ADDENDUM NO. 2

Life Sciences Collaboration
 1910 N. Antelope Valley
 Parkway
 Lincoln, Nebraska
 TCEP No.: 716-002-12
 Davis Design.: 12-0077
 BVH No.: L12018.unl
 November 27, 2013

Roof Plan & Skywalk Roof
 Plan - Area A

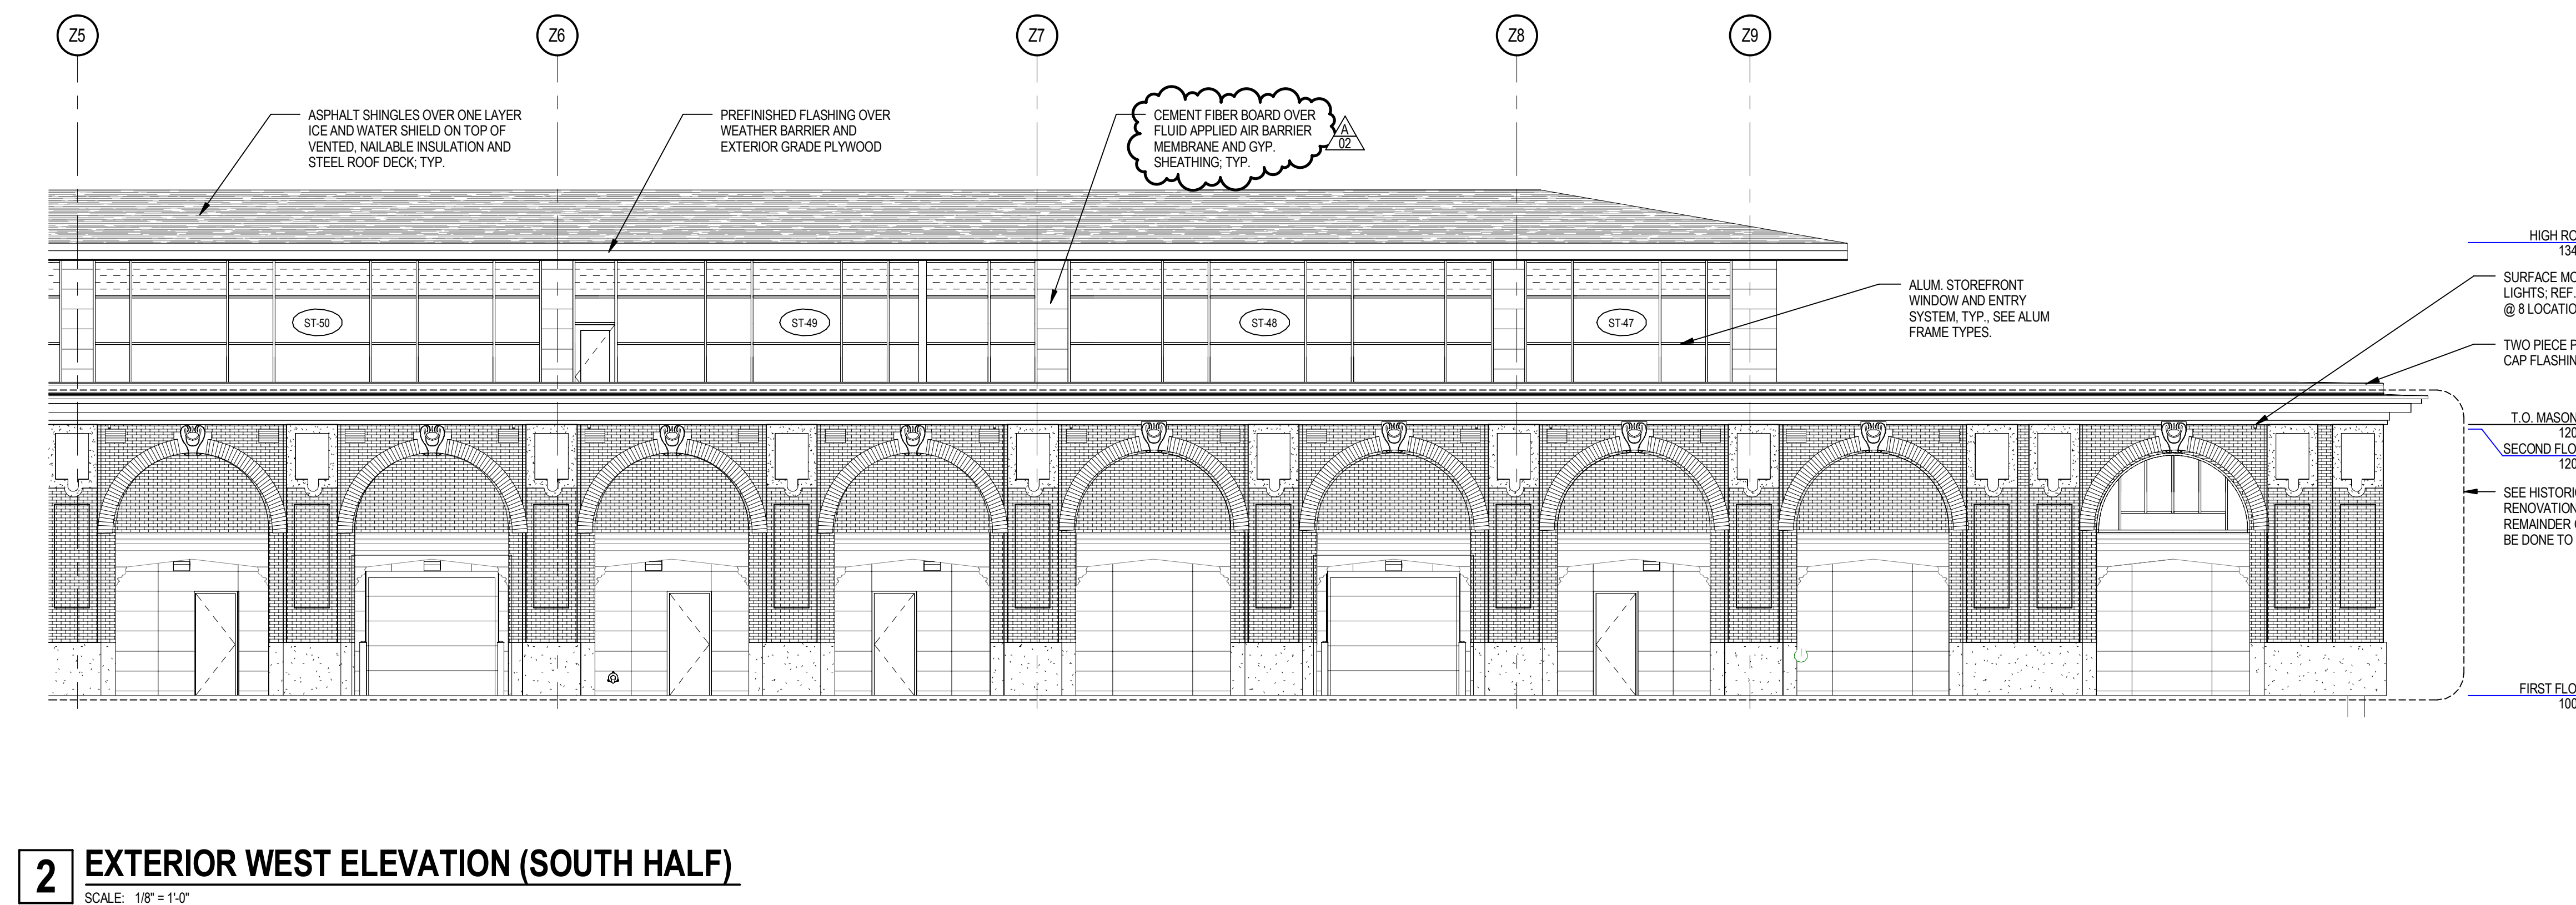
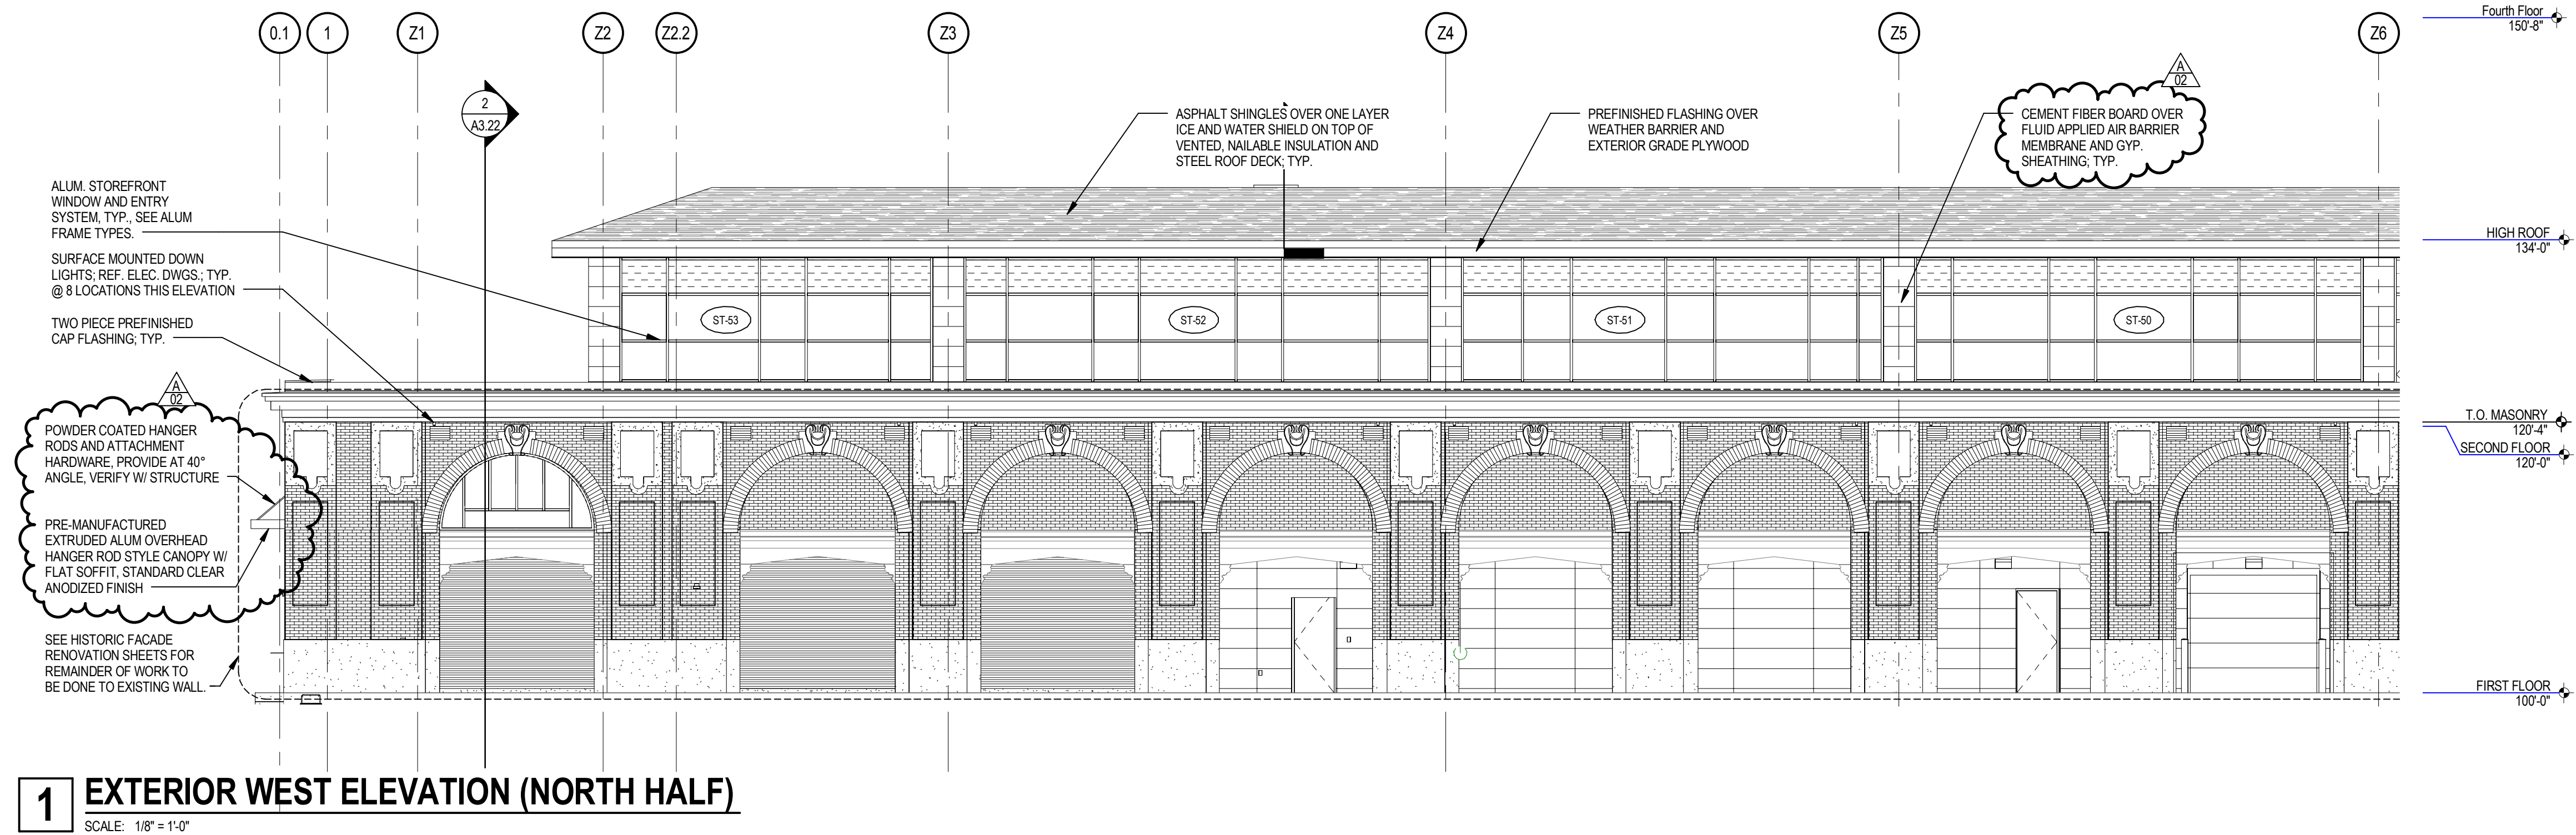
Item 2-43: Sheet A1.61 – Roof Plan & Skywalk Roof Plan – Area A

See revised sheet for window washing tie off system and walkway pads.

ST-60

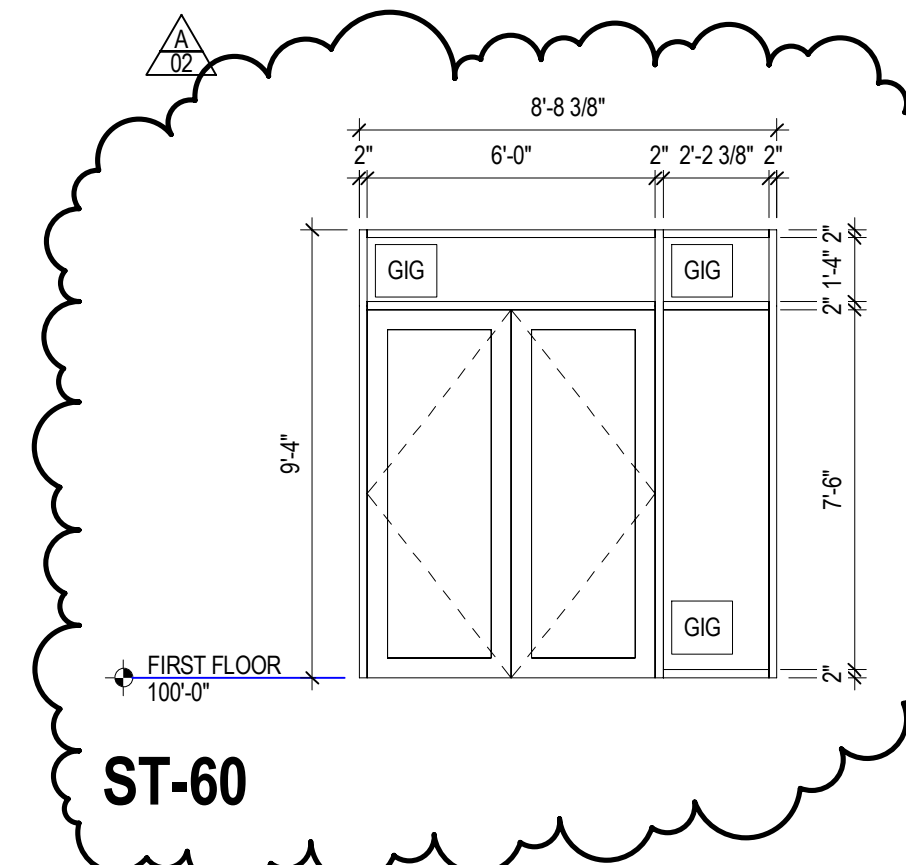
Item 2-48: Sheet A6.05 – Exterior Frame Types – Areas B, C, & D

See reissued sheet for revision of storefront elevation ST-60 and addition of ST-61.

First Floor HVAC Piping
Plan - Area C

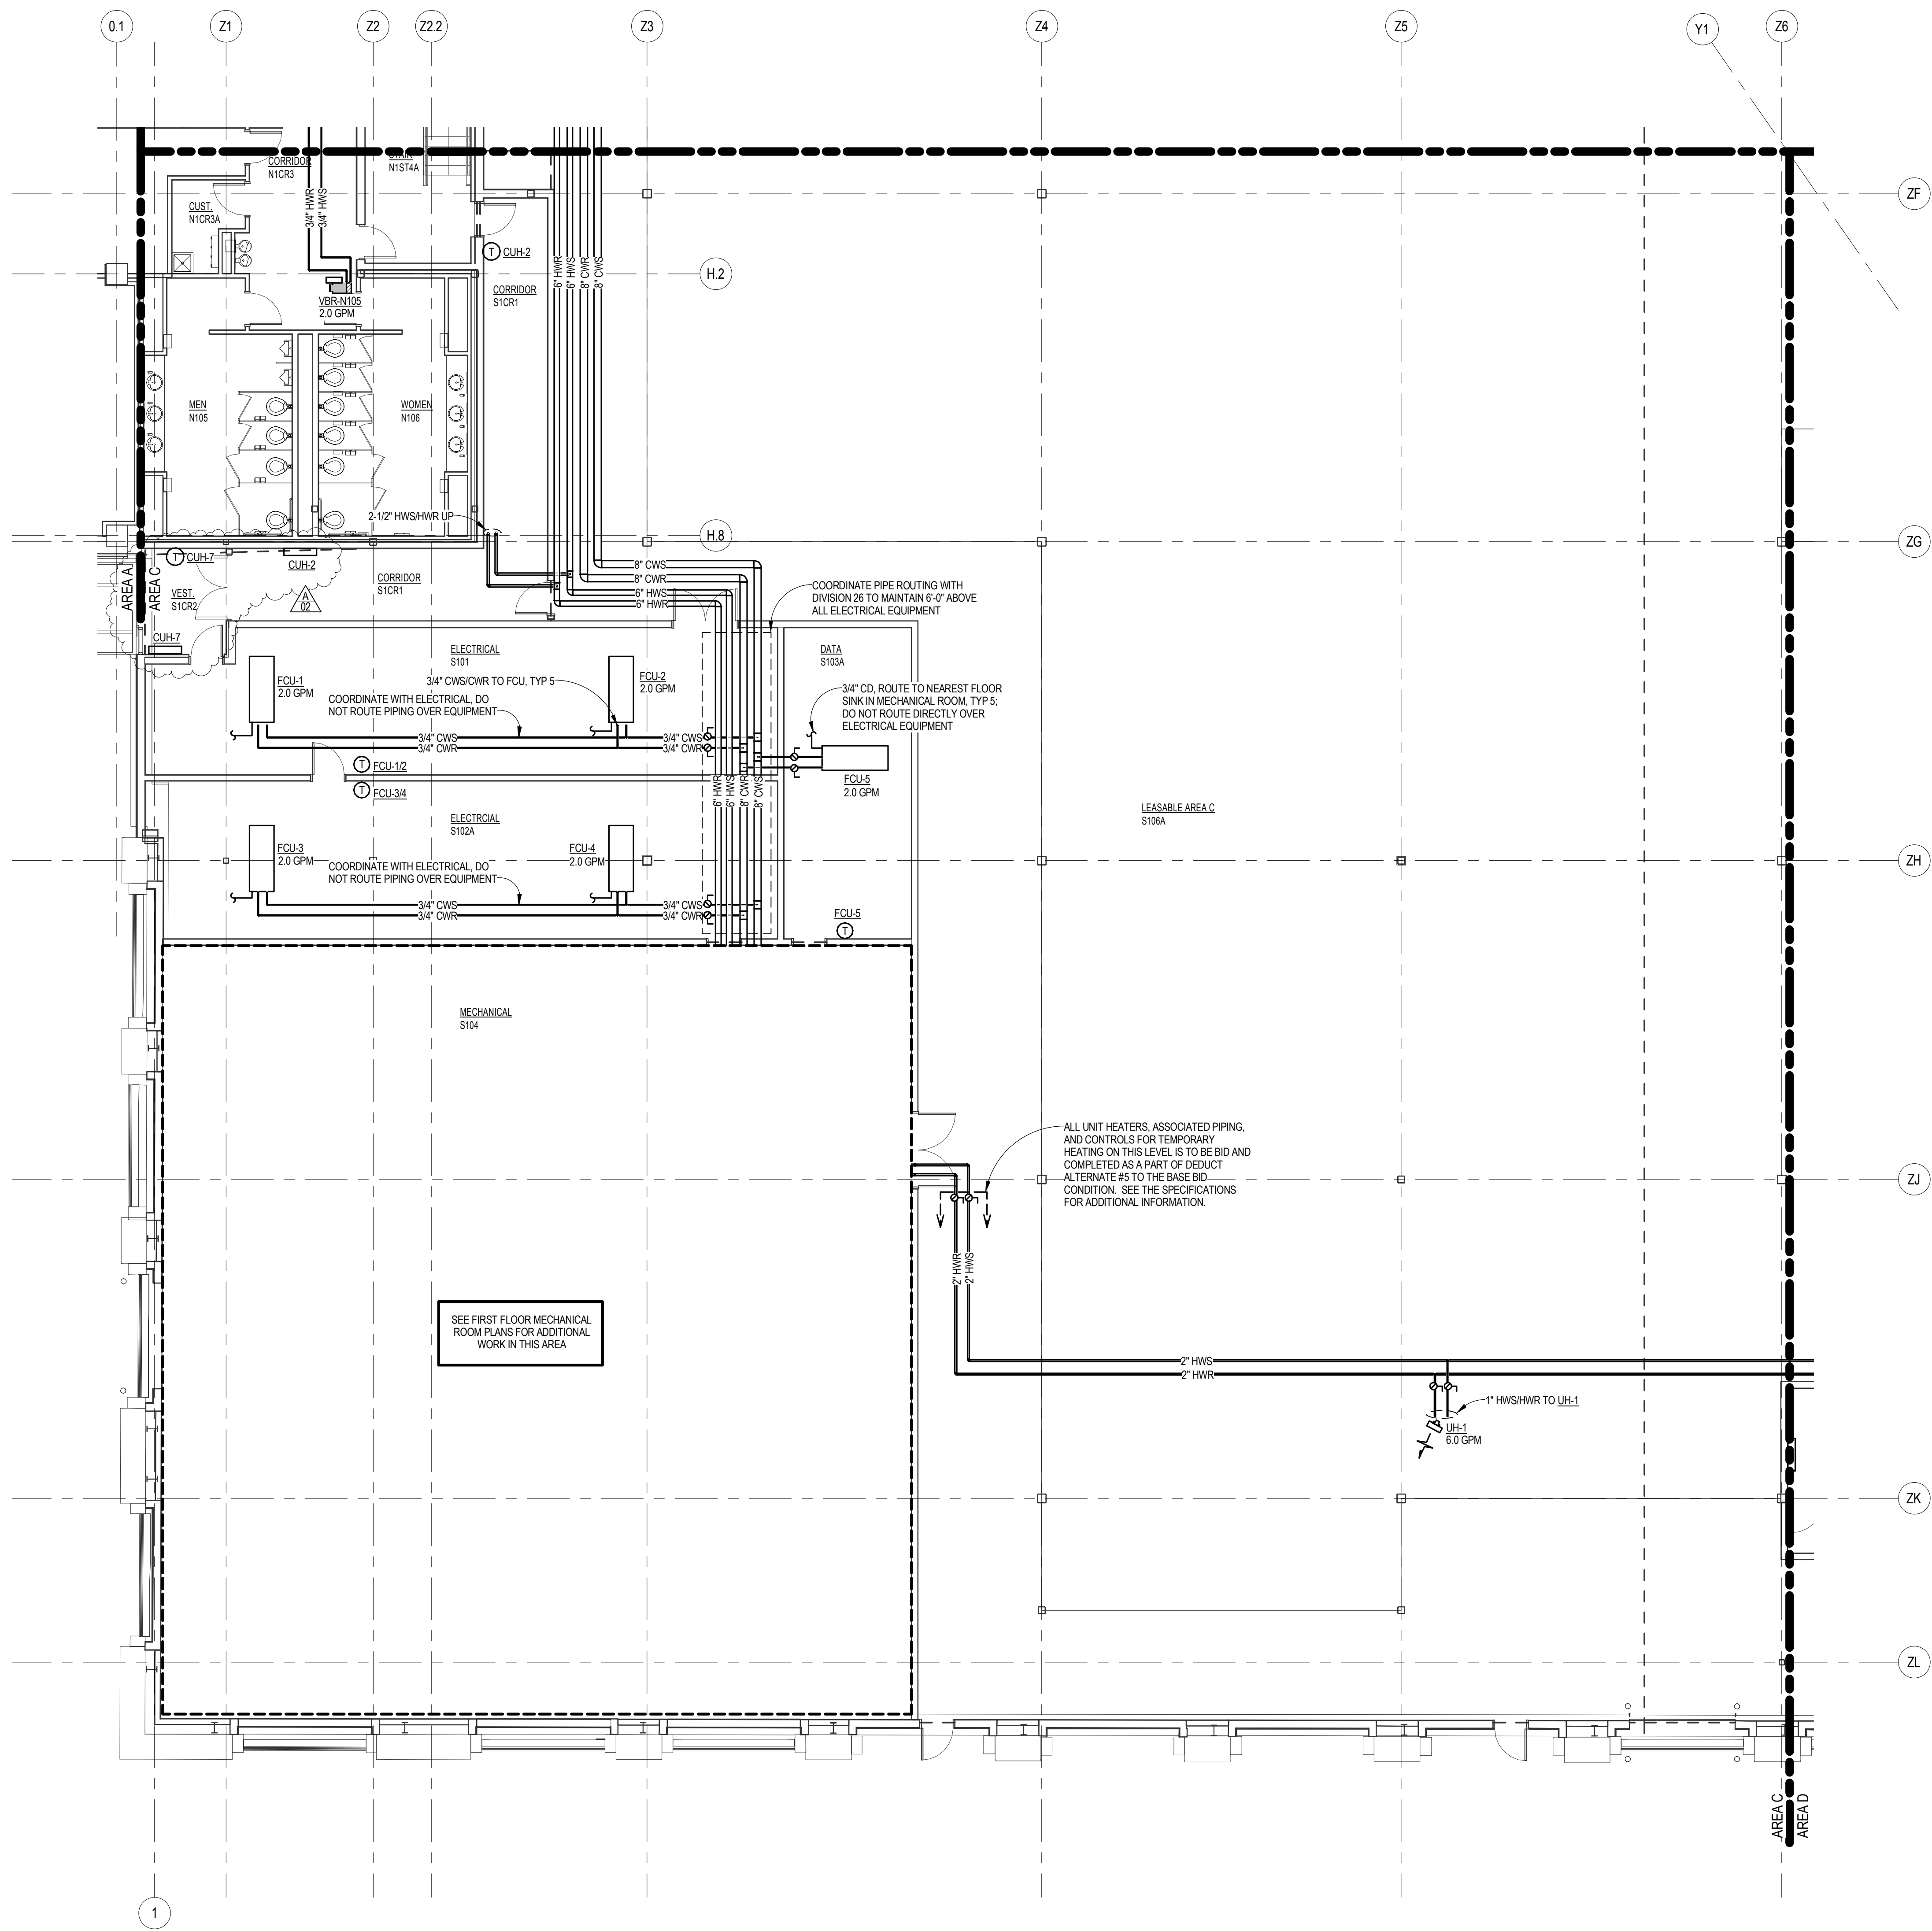
Item 2-51: M1.11 – First Floor HVAC Piping Plan – Area C

See reissued sheet for addition of CUH-7 and associated thermostat to new vestibule. Shift CUH-2 as shown on plan.
